GEOTECHNICAL CROSS SECTIONS

Subject: **RESPONSE TO CITY OF AGOURA HILLS - GEOTECHNICAL REVIEW SHEET DATED NOVEMBER 30, 2013 PREPARED BY GEODYNAMICS, INC. REGARDING THE GEOTECHNICAL SITE EVALUATION FOR THE PROPOSED AGOURA EQUESTRIAN ESTATES, EAST OF CHESEBRO ROAD AND NORTH OF US 101, AGOURA HILLS, CALIFORNIA, REPORT 2232-0FR-100, DATED JULY 24, 2013.**

Date: November 30, 2013
GDI #: 13.00103.0188**CITY OF AGOURA HILLS - GEOTECHNICAL REVIEW SHEET**

WO 2232-0-FR-100 Section D-D'

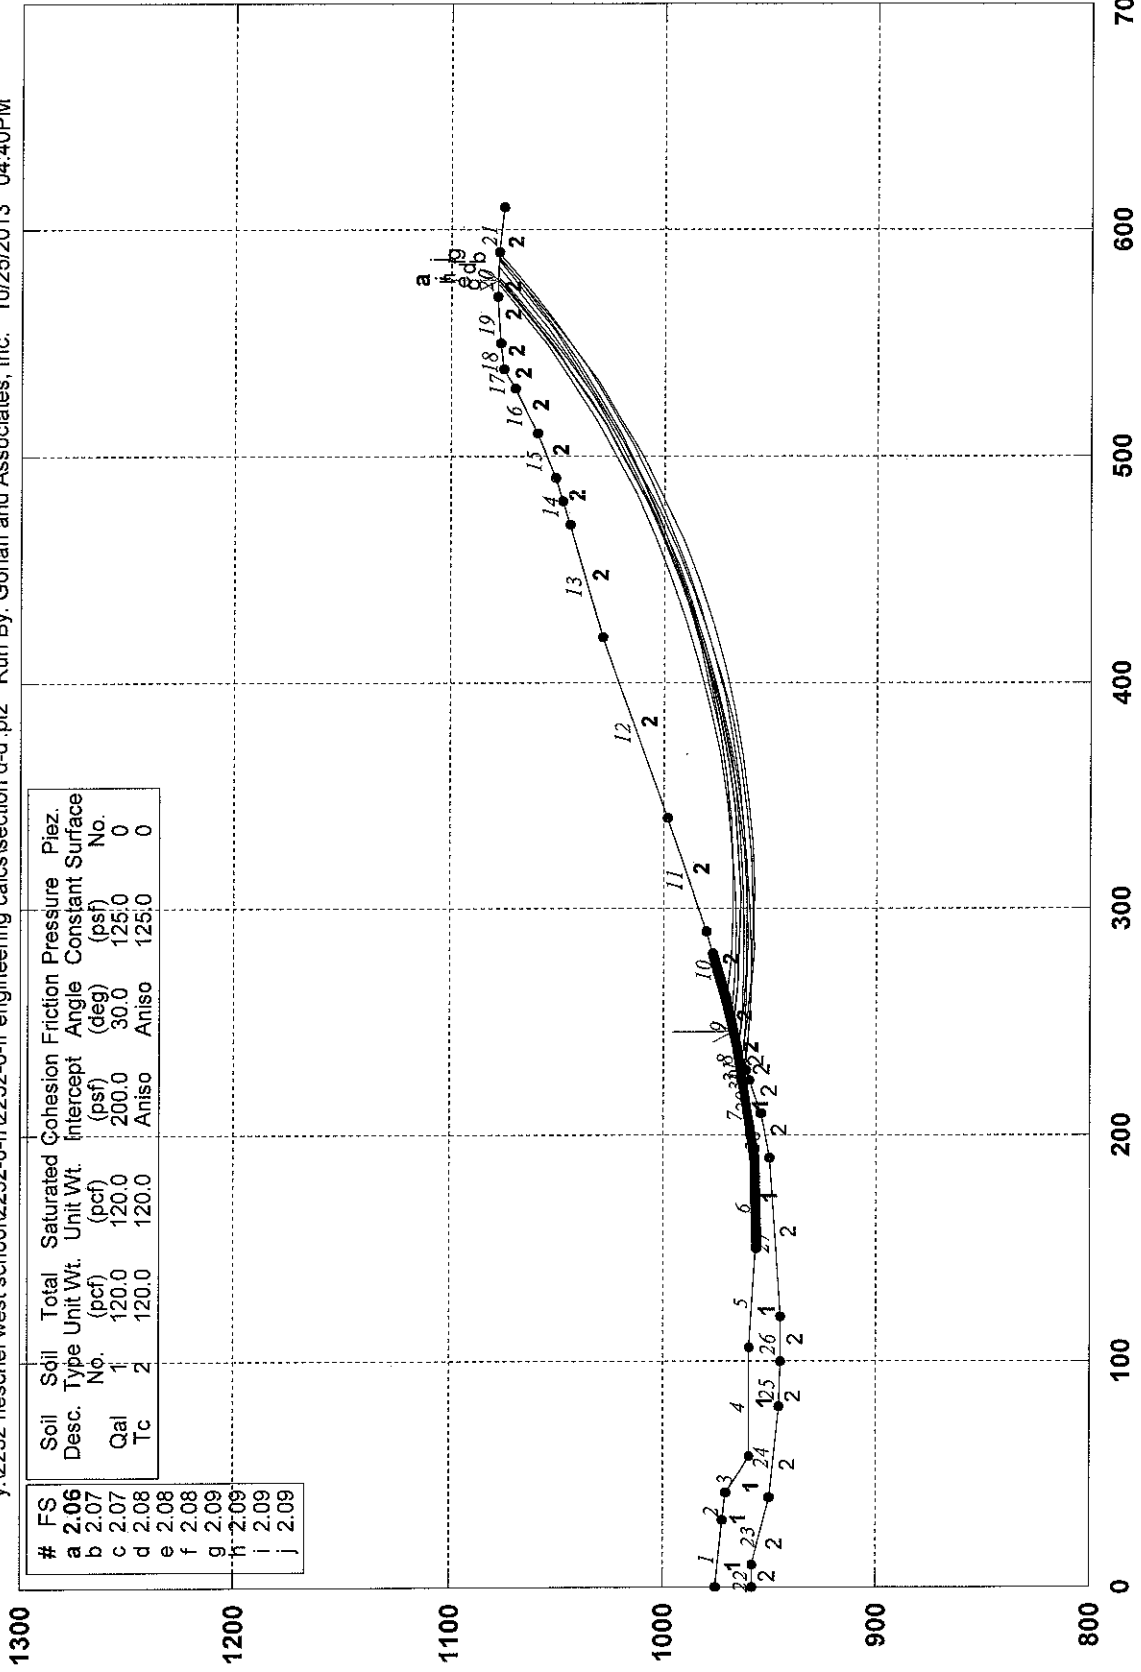
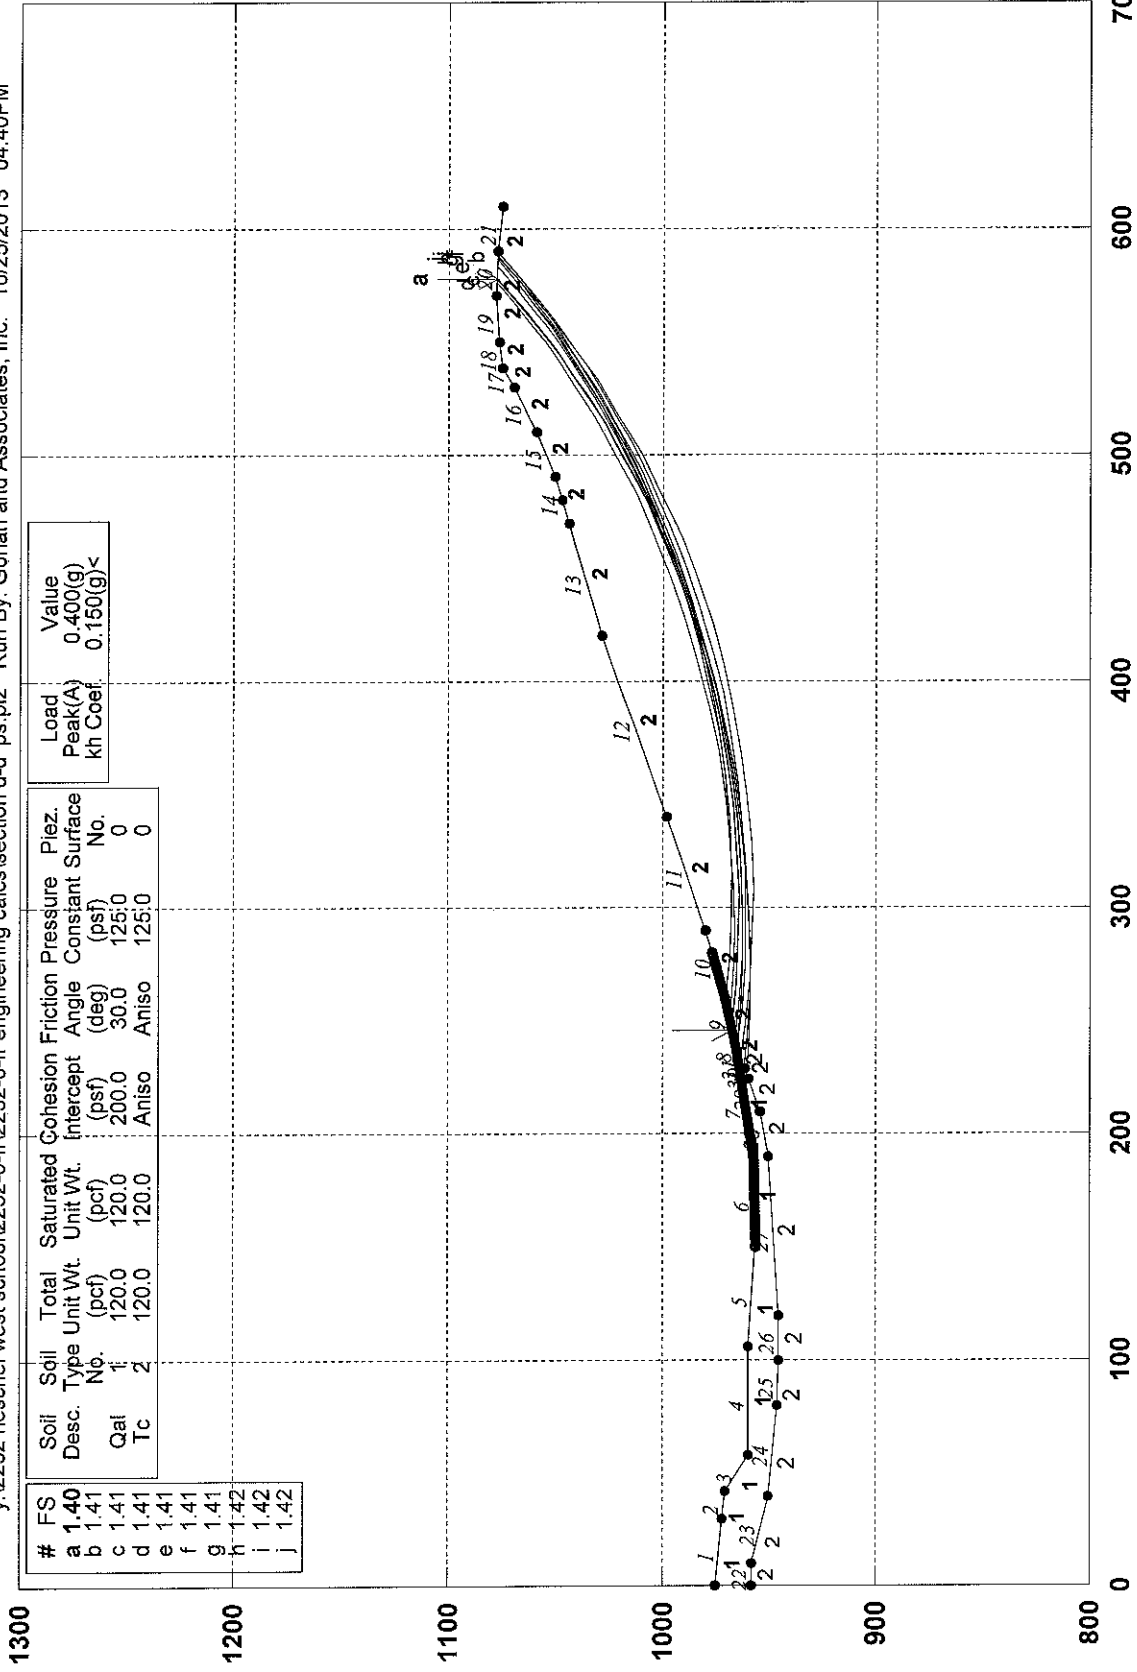
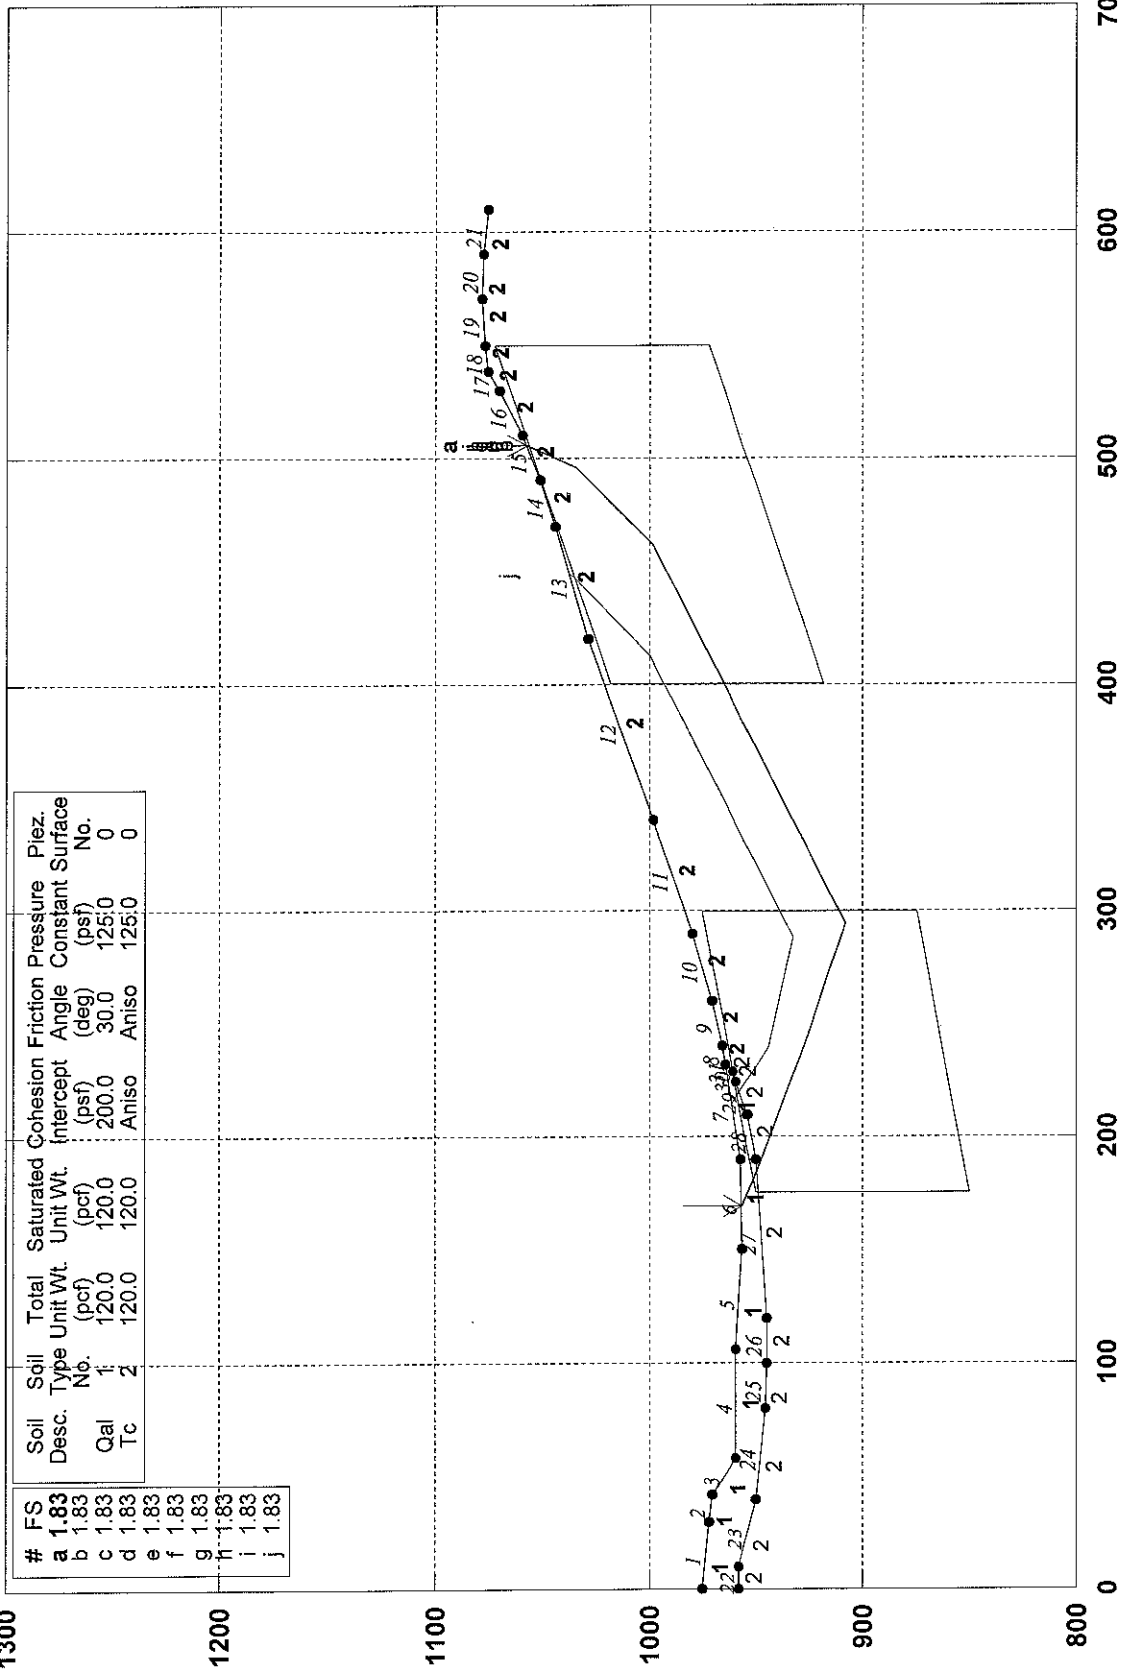
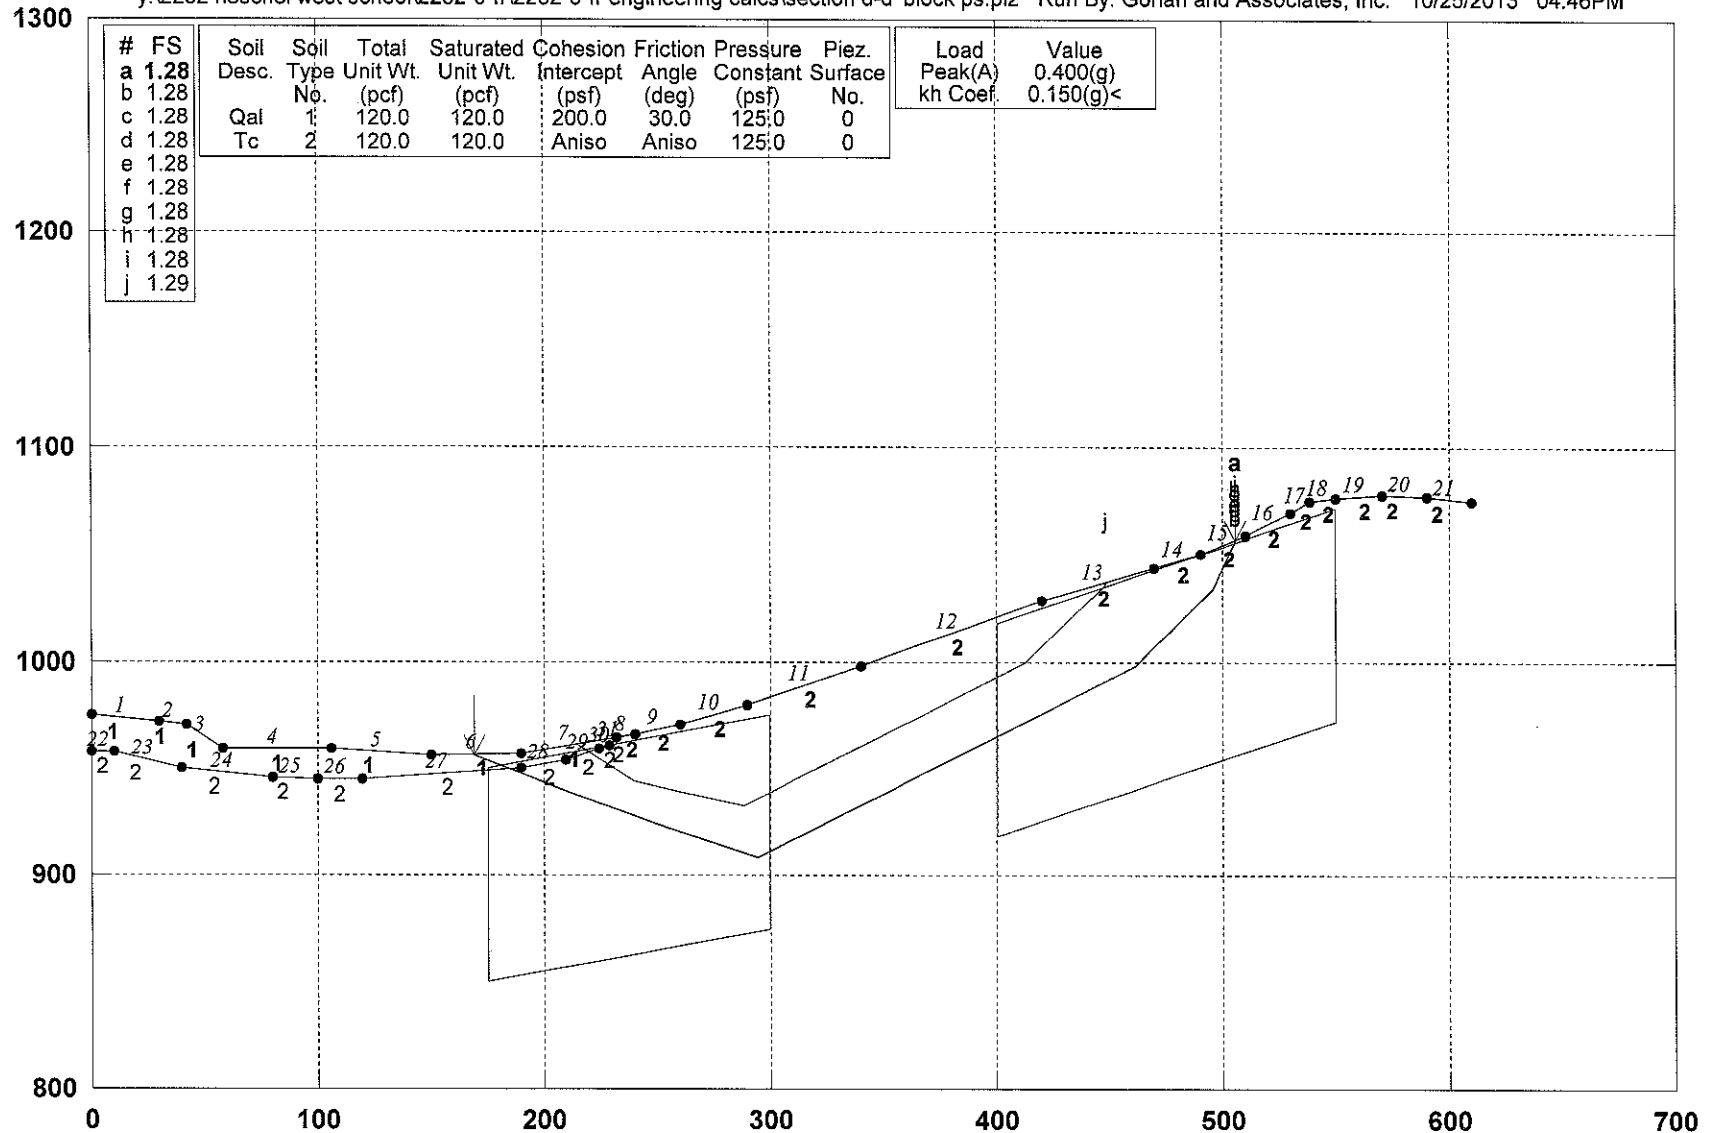
The consultant should prepare a cross-section along the steepest slope east of Boring 12. The cross section should extend to the top of the ridge. Slope stability analyses (rotational and translational if necessary) should be performed and mitigation measures should be recommended as necessary.

A cross section was constructed as requested through boring B-12 as shown in cross section D-D'. Cross section D-D' is shown on the current lot grading plan used for Plate 1. The geology of the slope was determined using the data from borings B-12 and B-13 with the data from boring B-13 projected onto the cross section. Slope stability analyses (both translational and rotational) were performed and included herein. See also Response to Comment 1.

Cross Section D-D has been added to Plate 1 and was evaluated for both rotational and translational failures using the previously established shear strengths. The results of the analyses indicate that the critical factor of safety is greater than 1.5 and 1.1 for static and pseudostatic conditions, respectively.

<p>Applied Earth Sciences Geotechnical Engineers and Geologists</p>	<h3>Direct Shear Testing</h3> <h3>Stress Strain Curves</h3>		Figure No.: 1
	Work Order: 2232-0-0-100	Source of Sample: B-10 @ 10'	
	Project: 0	Description: Calabasas Formation - Claystone	
Client: 0

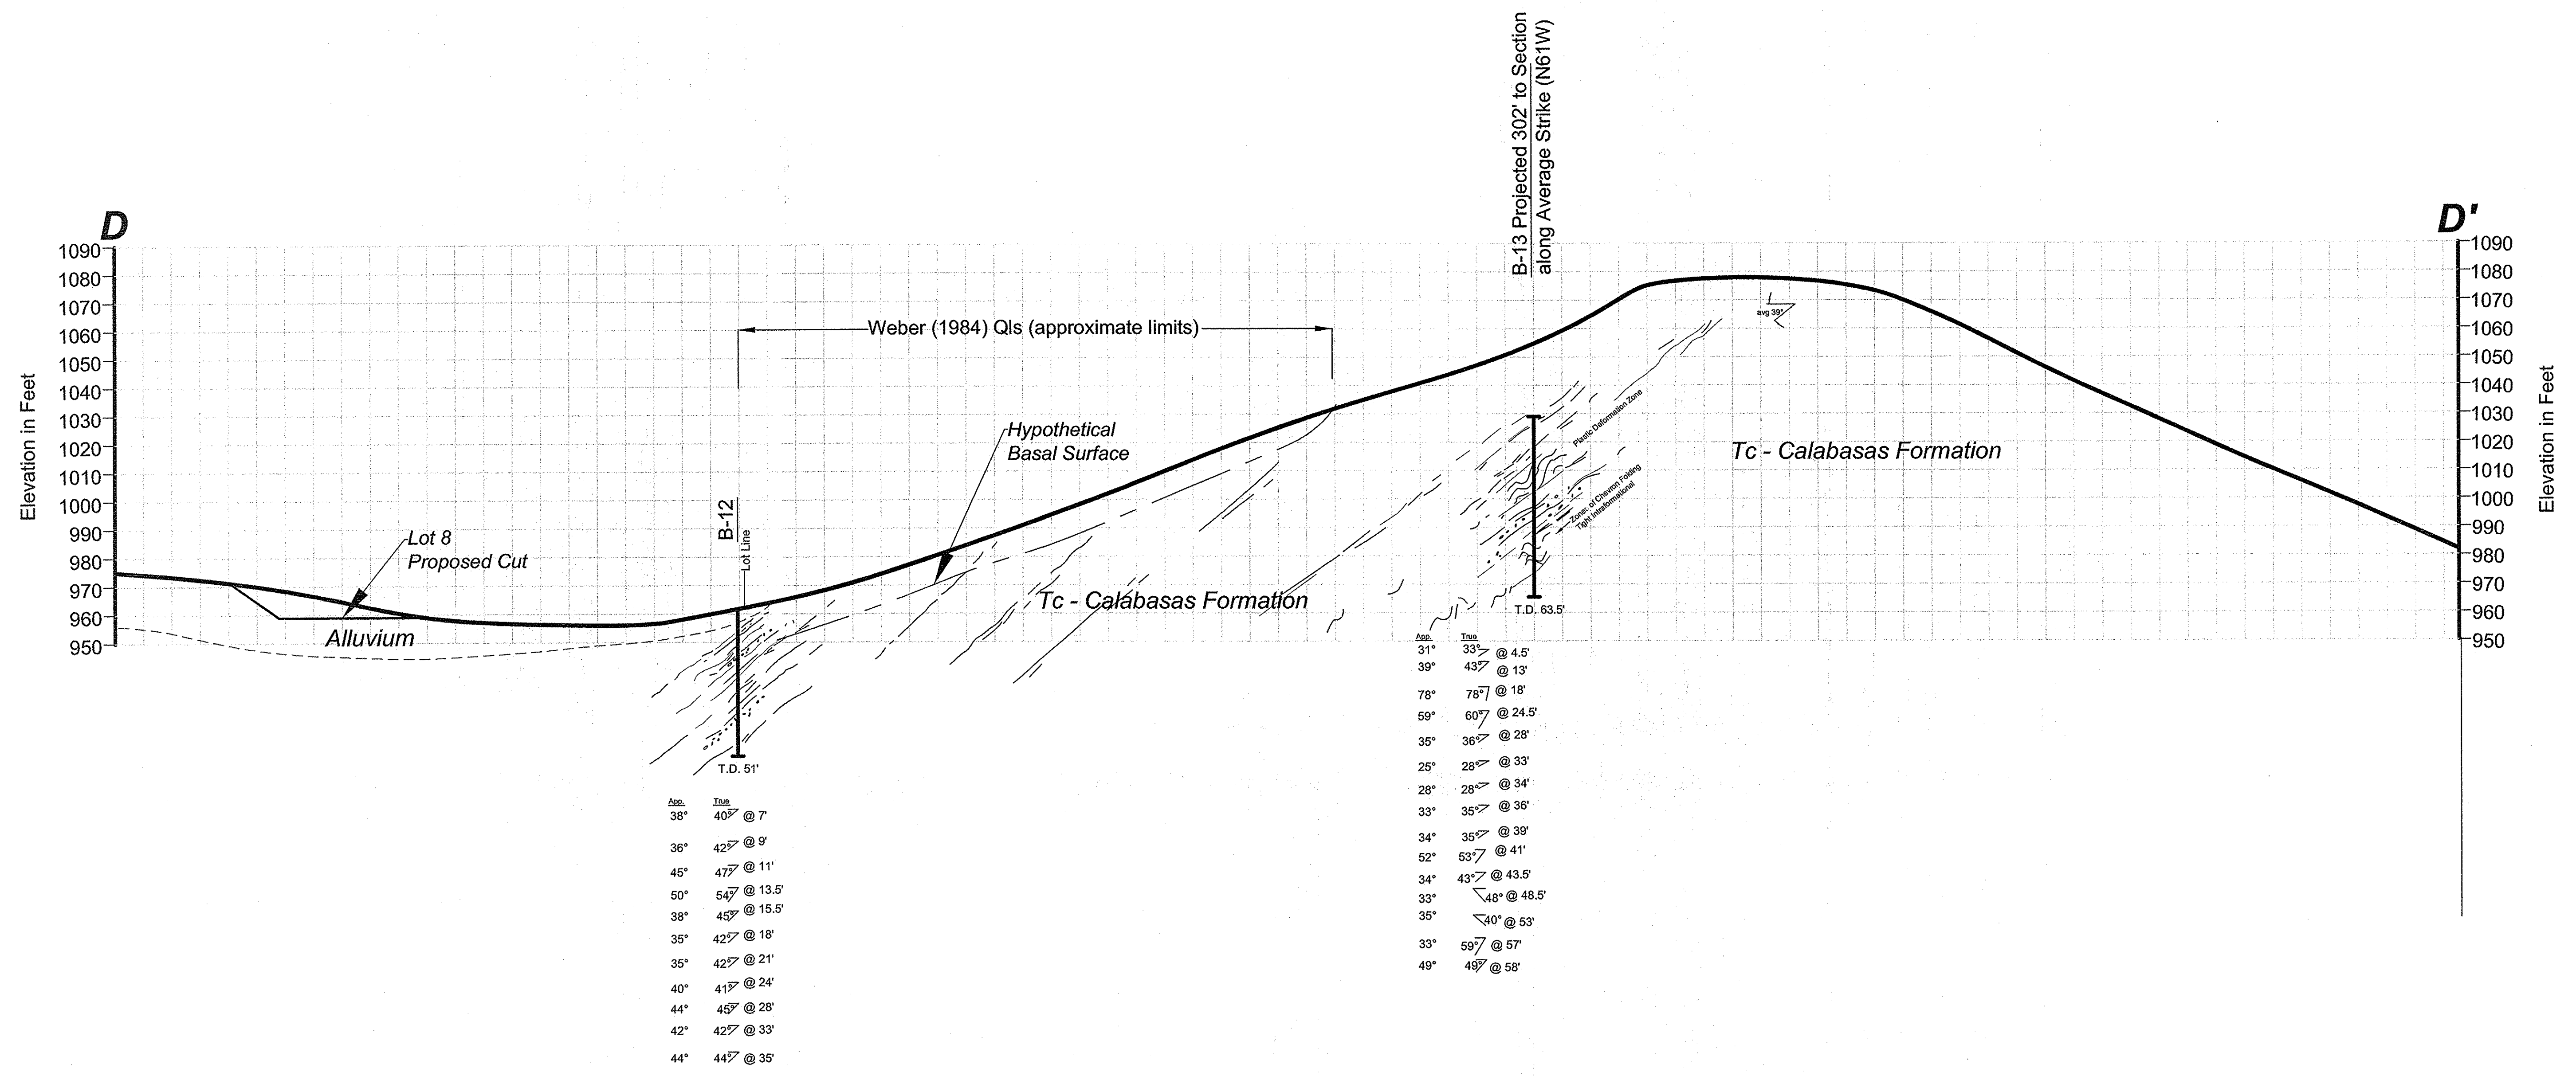
Note: The stress-strain curves included in Figure 1 indicate that shear resistance under normal stress of 1000 is greater than shear resistance under 3000 psf. There seems to be some inadvertent discrepancies in the provided plots. In addition, the cyclic stress-strain curves (stress-strain curves for repeated shear) should also be provided.

Note: The stress-strain curves included in Figure 1 indicate that shear resistance under normal stress of 1000 is greater than shear resistance under 3000 psf. There seems to be some inadvertent discrepancies in the provided plots. In addition, the cyclic stress-strain curves (stress-strain curves for repeated shear) should also be provided.

As discussed with the reviewer the stress strain was incorrectly provided in the reference report of November 12, 2013. The correct stress strain plots are attached hereto in Appendix A.
